SUBJECT: **Invitation for Bid # 10-0634-DS**
Pic Town Waterline Replacement Project-Phase 2
(Project No. 6074870)

ADDENDUM # 5

**Pic Town Waterline Replacement Project-Phase 2
(Project No. 6074870)**

Subject: Responses to Pre-Bid and Bid Questions for Pic Town Phase II

DRAWING NO.
P-12

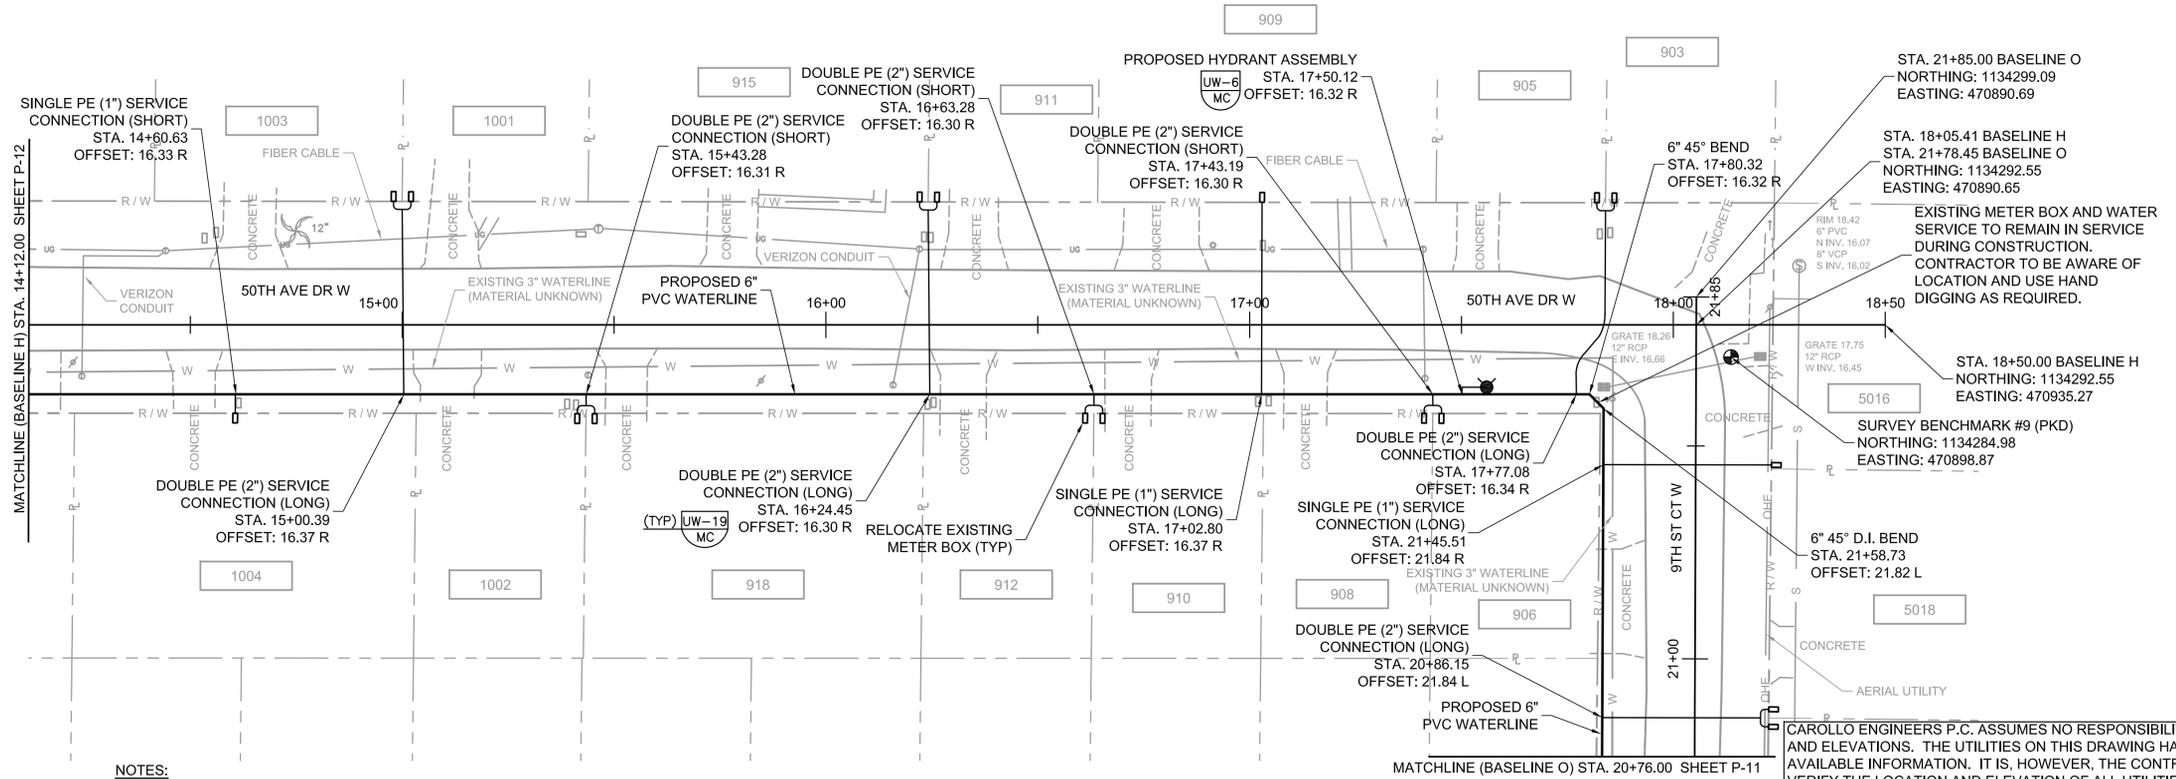
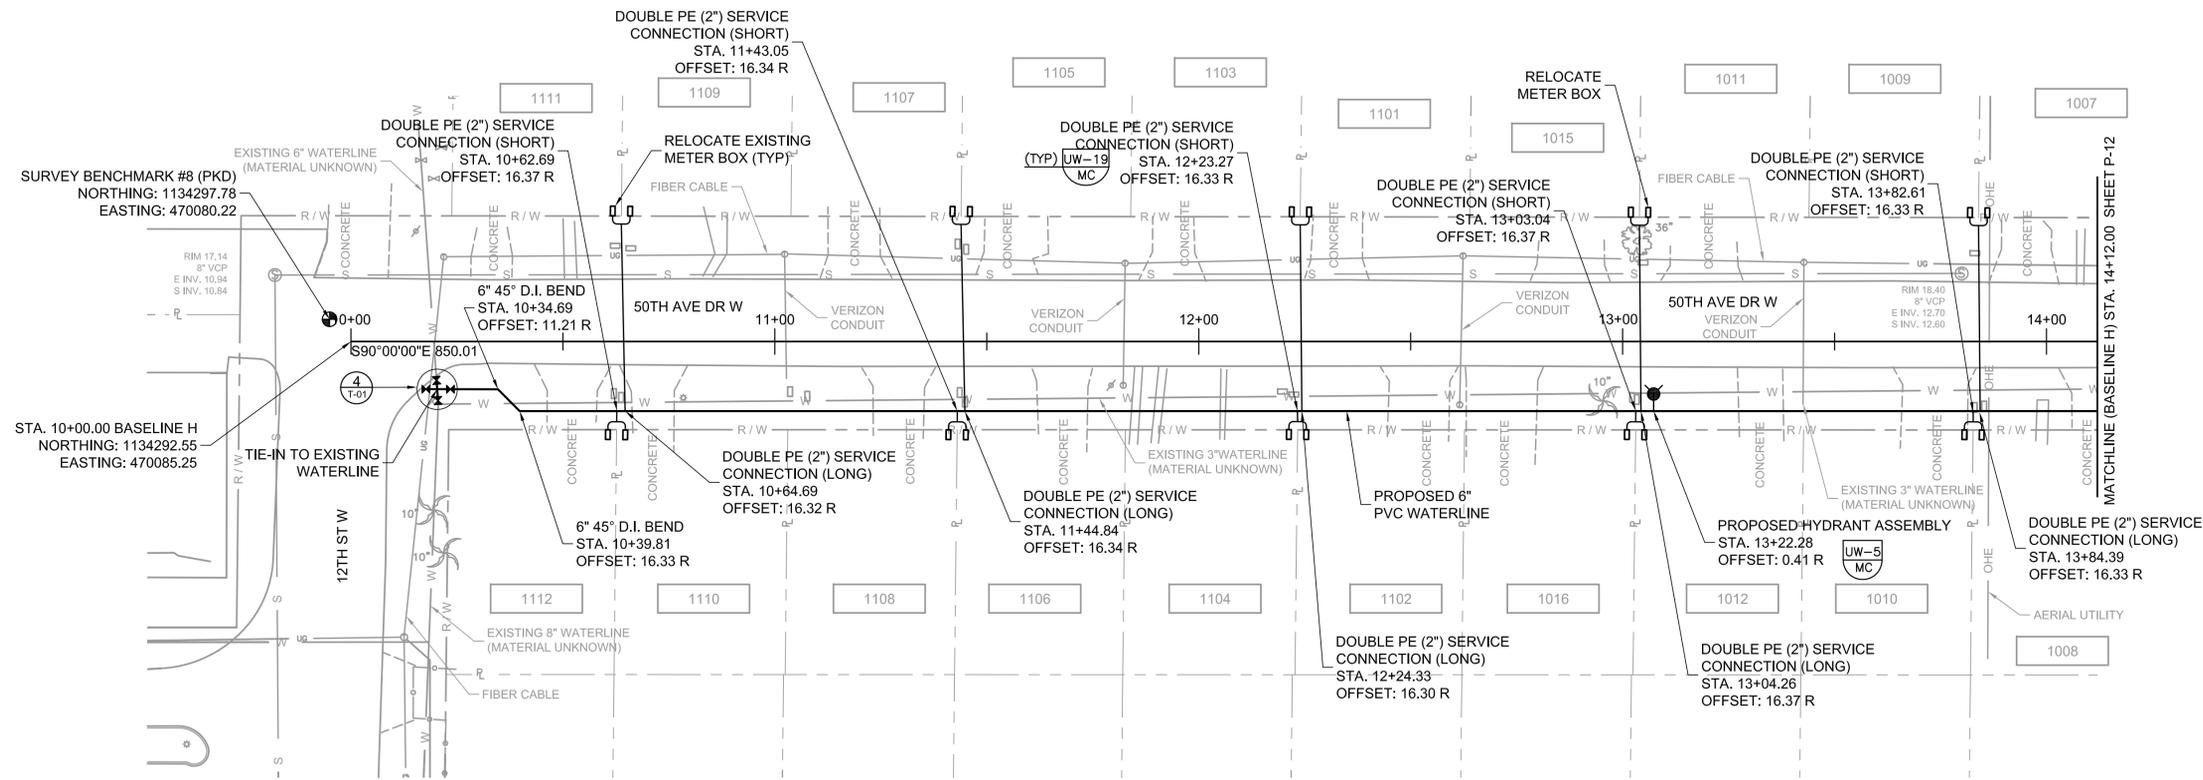
80. On sheet 10 of 13 lot #906 at the corner of 50th Ave. Plz. W. and 9th St. W. the driveway coming off the property to the North does not seem to be shown. The plans indicate installing a fire hydrant right in the middle of where this driveway is located.

The fire hydrant assembly has been relocated, see revised Drawing P-12.

JOB NO. 7880E.10
 DRAWING NO. T-01
 SHEET NO. 11 OF 14

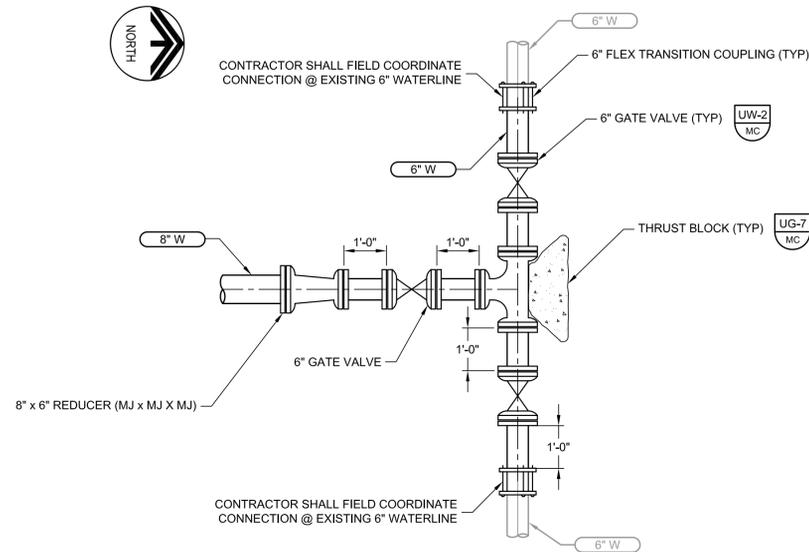
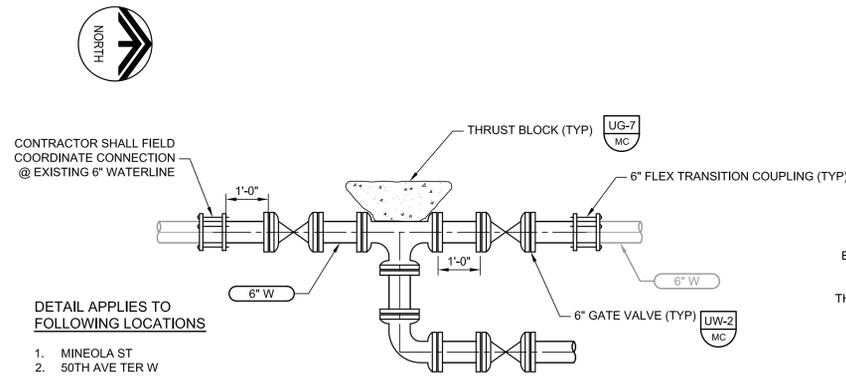
42. Plan sheet 4, Station 23+31, Should there be an 8" gate valve at the point of tie in to test against and use as isolation? It is rather dangerous testing against an old existing valve.

The tie-in to the existing waterline has been revised; see Drawings P-06 and T-01.
